STAFF REPORT

SUBJECT: H-2020-0074
TM Center - PP
Ten Mile Crossing – MDA, RZ

LOCATION: East of S. Ten Mile Rd. & south of W.
Franklin Rd., in the north half of Section
14, Township 3N., Range 1W.

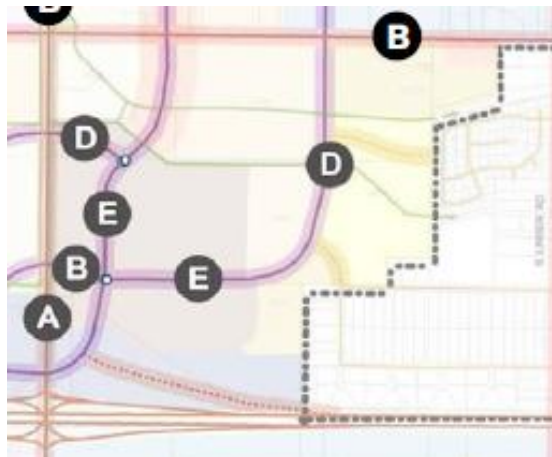
Two (2) driveway accesses via Franklin Rd. are depicted on the plat – one to the east and one to the west of New Market/Benchmark on Lot 4, Block 3 and Lot 4, Block 4. The conceptual

development plan included in the DA for the Bainbridge Franklin property depicts the eastern driveway access via Franklin; however, the Applicant states this property is no longer planned to develop in that manner. ACHD has *not* approved either of these accesses and is requiring a traffic analysis be submitted to demonstrate additional driveways are necessary to serve the site. The UDC's ([11-3A-3](#)) intention is to improve safety by combining and/or limiting access points to arterial streets to ensure motorists can safely enter all streets. **City Council should determine if a waiver to the standards in UDC 11-3A-3 is appropriate for the proposed driveway accesses in the absence of a conceptual development plan for this area.** These accesses are prohibited unless specifically approved by the City and ACHD.

STREET SECTION: S. WAYFINDER AVE.

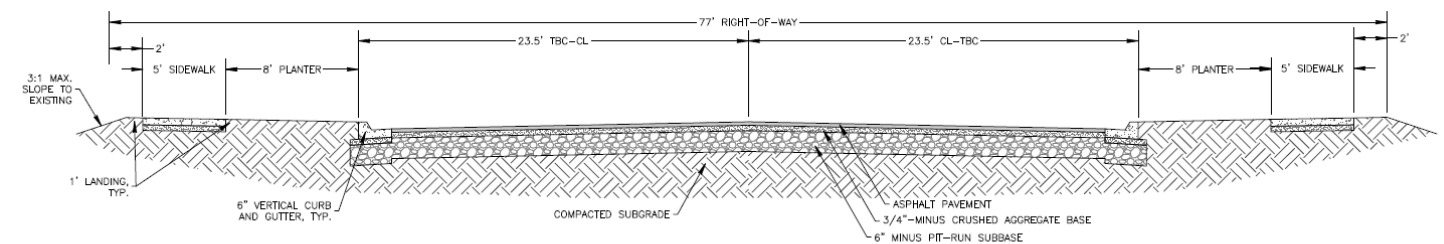
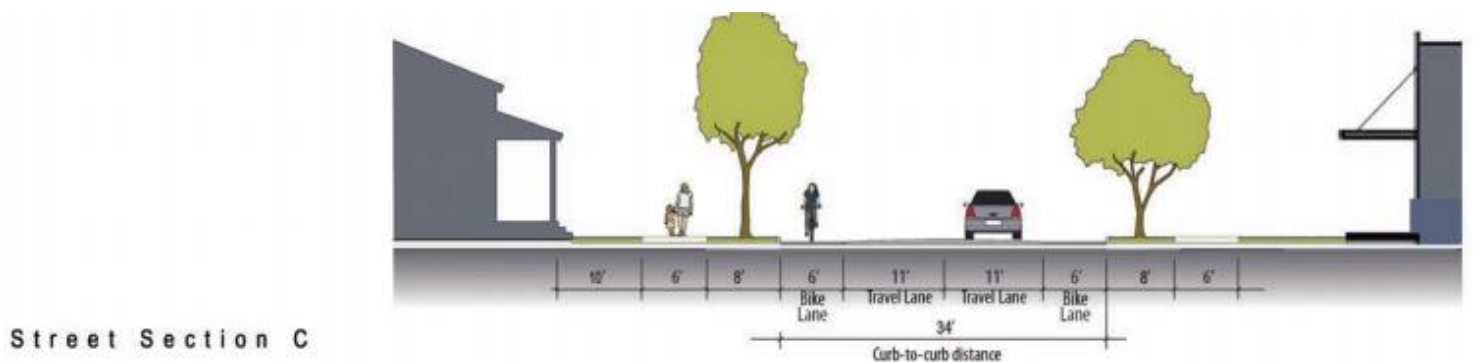
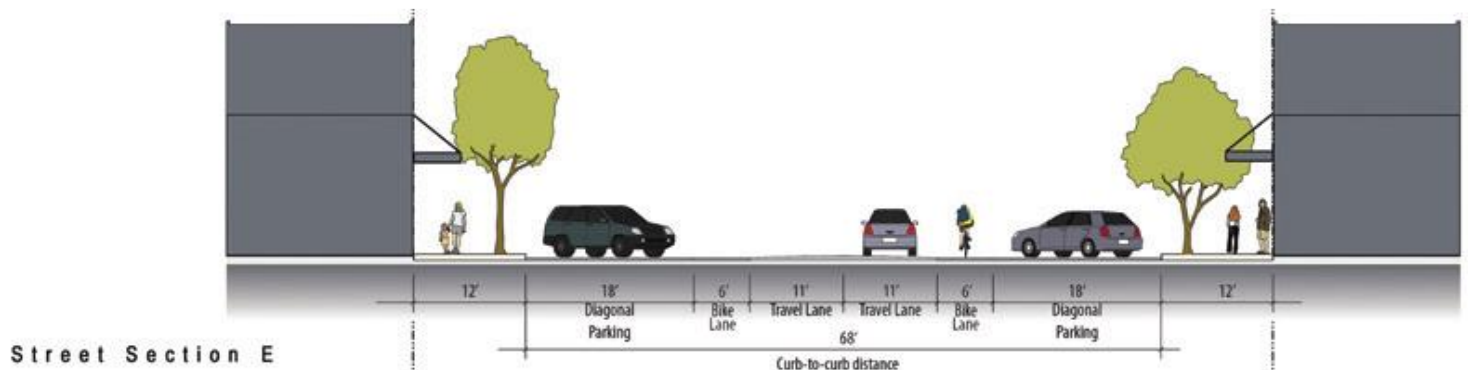
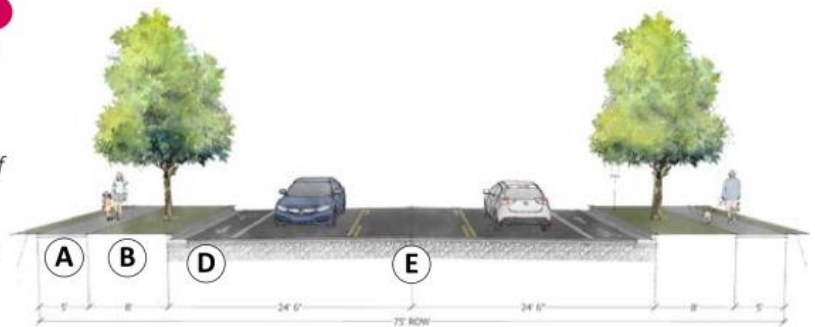
The western north/south collector street, proposed as S. Wayfinder Ave., designated as “E” (minor collector street), extends from a future signalized intersection at W. Franklin Road to the south to Vanguard. The portion north of Cobalt was approved with TM Creek subdivision. **Per the Map and as required by the existing DA for Ten Mile Center, this street should have been constructed per the guidelines for Street Section E shown below with two (2) travel lanes, bike lanes, diagonal parking and 12' sidewalks with trees in wells (see pgs. 3-21 & 3-23 in the TMISAP).** However, the street section approved by ACHD and constructed is a standard street section with (2) travel lanes, a center turn lane, bike lanes, 8-foot wide planter strips, a 5-foot wide detached sidewalk on the west side and an 8-foot wide pathway on the east side with no on-street parking, similar to that of major collector street (i.e. Street Section C, shown below) (see street section from the proposed plat and detail from the proposed design guidelines below). Because of the changes to the FLUM in this area from LC to Commercial and this street providing access to the employment uses to the south, which will likely result in a higher traffic volumes, Staff is in general support of the design as constructed. Minor collector streets in the Plan differ from the MSM's town center collector street in that they don't have a center turn lane and have diagonal instead of parallel parking.

Minor collector streets serve as the primary retail streets and are pedestrian-oriented and defined by street-level storefronts. Buildings are built to 12-foot wide sidewalks with street trees in wells and

pedestrian-scale lighting. A 5-foot wide dry-utilities corridor should be provided along both sides of the street curb; both wet utilities may be located in the street; and streetlights should be placed in the dry utilities corridor on either side of the street.

STREET SECTION: S. NEW MARKET AVE.

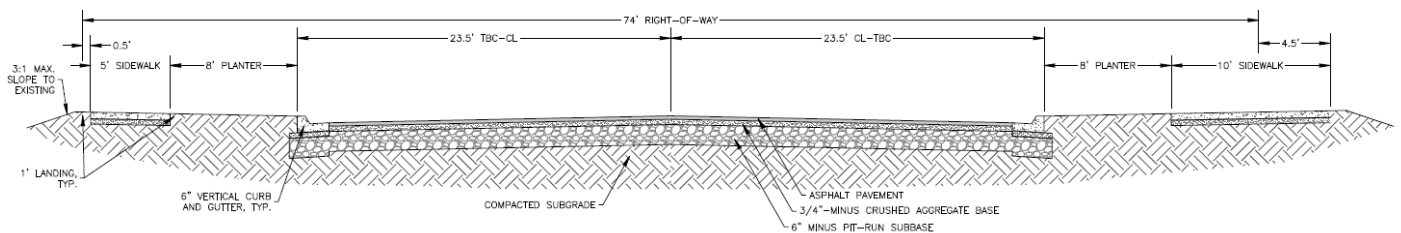
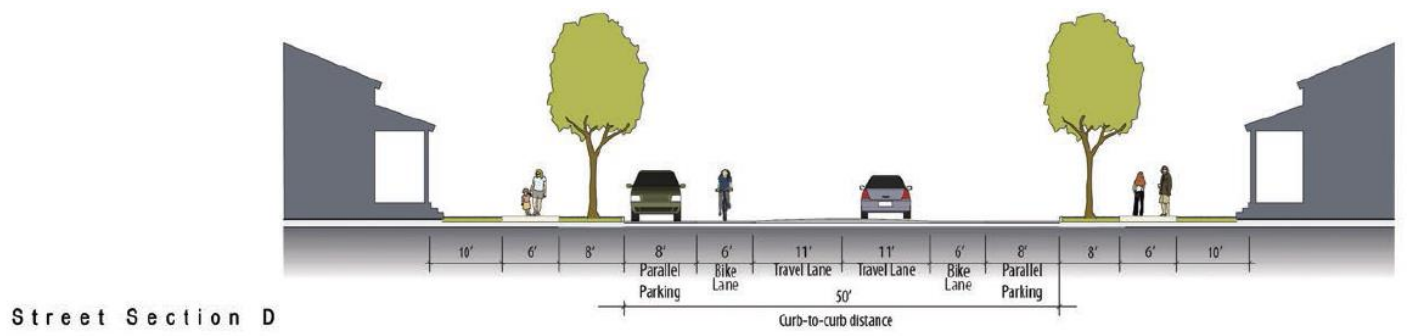
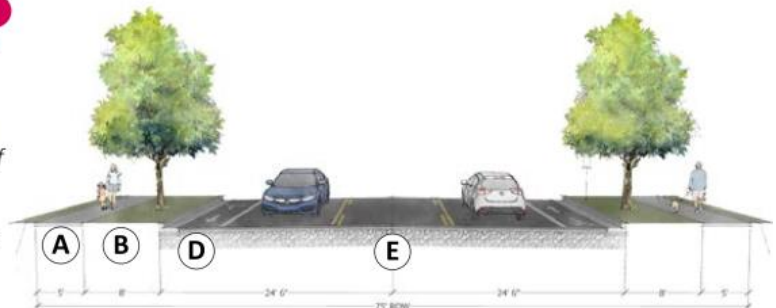
The eastern north/south collector street proposed as S. New Market Ave./Benchmark Ave., designated as “D” (residential collector street), will extend from Franklin Rd. to the south boundary of the site and connect to Navigator Dr. in the TM Crossing project. **This street should be constructed in accord with the guidelines for Street Section D shown below with two (2) travel lanes, bike lanes, parallel on-street parking (if allowed by ACHD), 8’ tree-lined parkways and detached sidewalks per the TMISAP and as required by the existing DA’s for Ten Mile Center and Calnon (see pgs. 3-21 & 3-23 in the TMISAP).**

The street section from the proposed plat and a detail from the proposed design guidelines shown below differ from a residential collector street in that there is a center turn lane, wider travel lanes and no on-street parking. ACHD has approved the proposed design; however, Staff does *not* support the proposed design as it’s not consistent with the TMISAP and the existing DA’s and therefore, recommends revisions consistent with Street Section D below with on-street parking. ACHD will have to review and approve revised street sections if changes are required to the proposed design – although on-street parking is desired and recommended, ACHD will need to review and determine if it’s safe to provide. *Staff discussed the discrepancies between the proposed plat and the town center collector in the MSM and Street Section D with ACHD and was told that although the Livable Street Design Guide allows for parking on a collector street it isn’t always appropriate in all locations – because we don’t know the end users for lots adjacent to these streets (a conceptual development plan or use plan wasn’t submitted) it’s difficult to determine if on-street parking will be appropriate. Residential collector streets in the Plan differ from the MSM’s town center collector street in that they don’t have a center turn lane and have a wider buffer zone.*

STREET SECTION: W. COBALT DR.

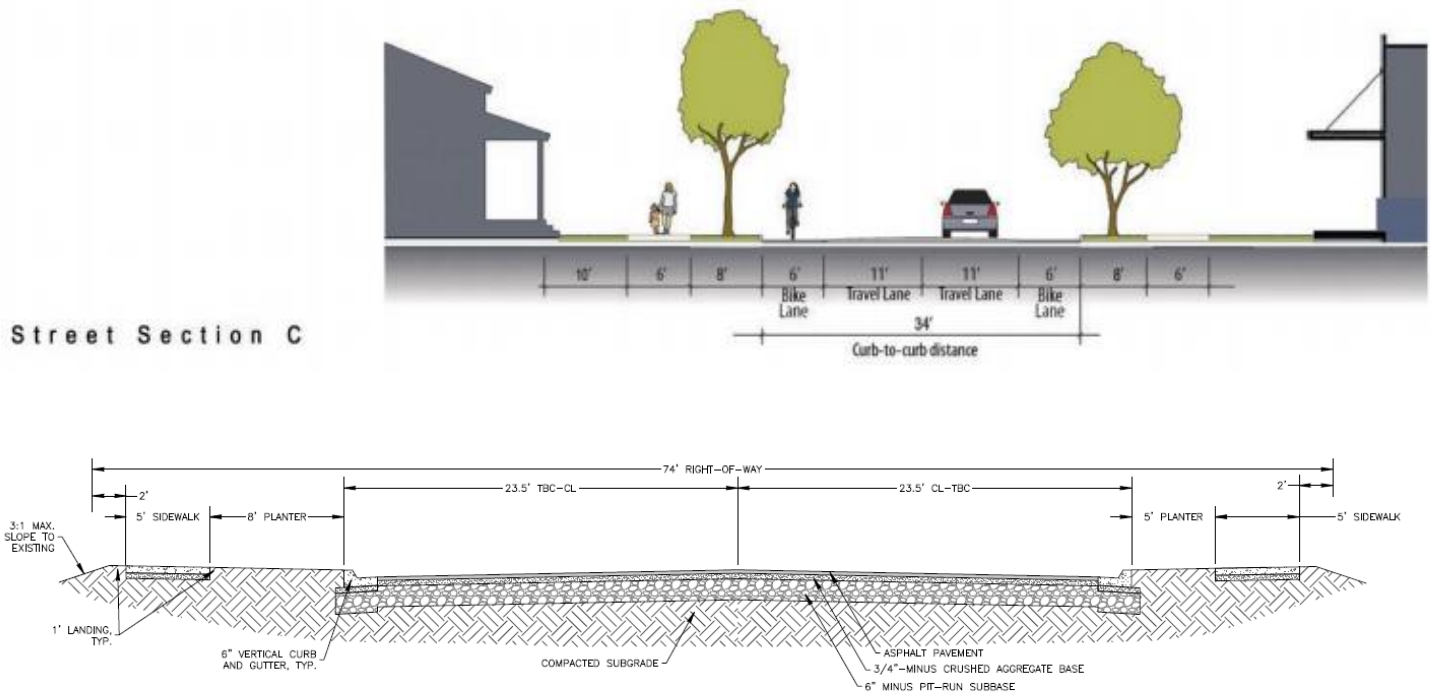
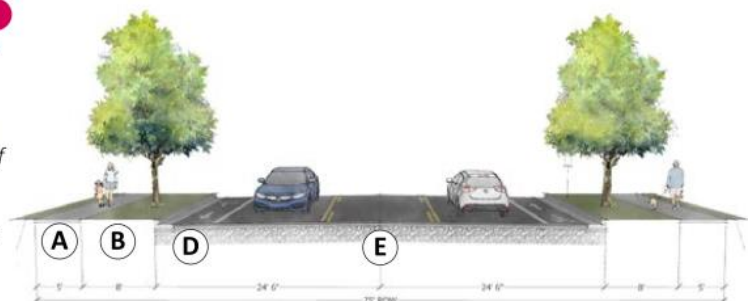
Neither the SSM shown above, nor the MSM, depicts an east/west collector where W. Cobalt Dr. is proposed to extend between Wayfinder and New Market although it does depict such further to the south in alignment with the access via Ten Mile Rd. along the southern boundary of this site which was actually constructed further to the south (i.e. Navigator Dr.) as discussed above. This southern section is designated as a minor collector street ("E") on the Street Section Map in the TMISAP and as a town center collector on the MSM. The portion of Cobalt west of Wayfinder is designated as a residential collector street (Street Section D) but was approved to be constructed as a major collector street closely aligning with Street Section C due to residential uses not being planned at that time in that area – since that time, the development plan changed and multi-family residential uses have been constructed along the north side of the street, east of S. Innovation Ln.

Street Section C, the street section from the plat and a detail from the proposed design guidelines are shown below. The western portion of Cobalt in front of the TM Creek East apartments project was previously approved as part of ACHD's action on that project and has been constructed.

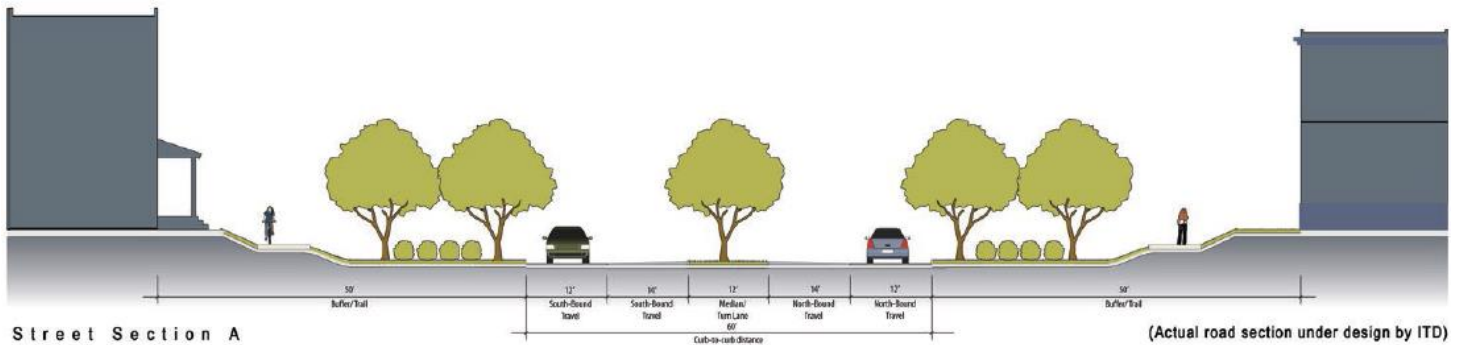
South Ten Mile Rd., an existing arterial street along the west boundary of the site, is designated as a modified 4-lane parkway (“A”) on the Street Section Map. **Buildings should address the street but be set back some distance from the roadway to provide security to the pedestrians and bikes and a wide tree lawn and detached trail should be provided as shown on Street Section A below. Streetlights should be located in the tree lawn area and should be of a pedestrian scale. Dry utilities should be located back of the curb in the dry utilities corridor.**

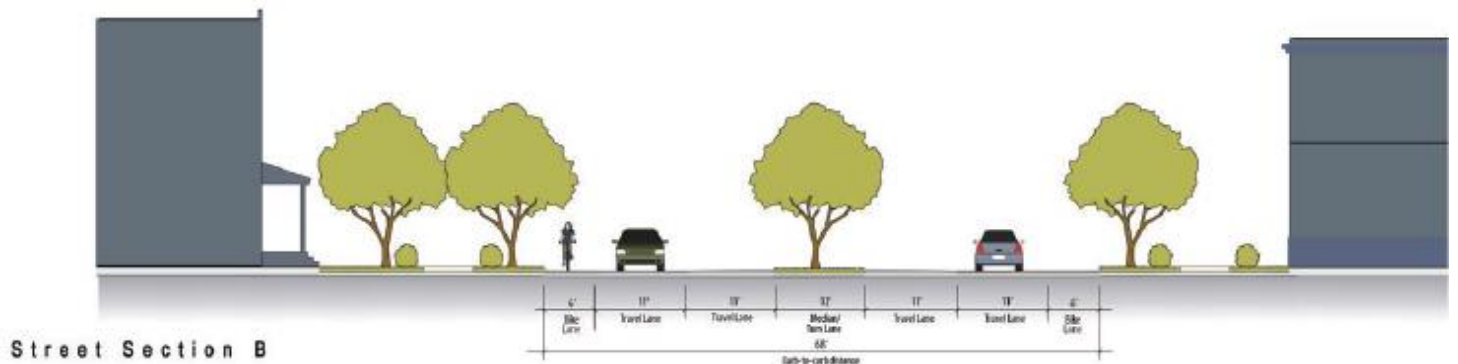
West Franklin Rd., an existing arterial street along the north boundary of the site, is designated as a typical 4-lane parkway (“B”) on the Street Section Map. **Buildings should address the street but be set back some distance from the roadway edge to provide for a tree lawn and detached sidewalk to provide security to the pedestrian as shown on Street Section B below. Streetlights should be located in the tree lawn area and be of a pedestrian scale. Dry utilities should be located back of the curb in the dry utilities corridor.**
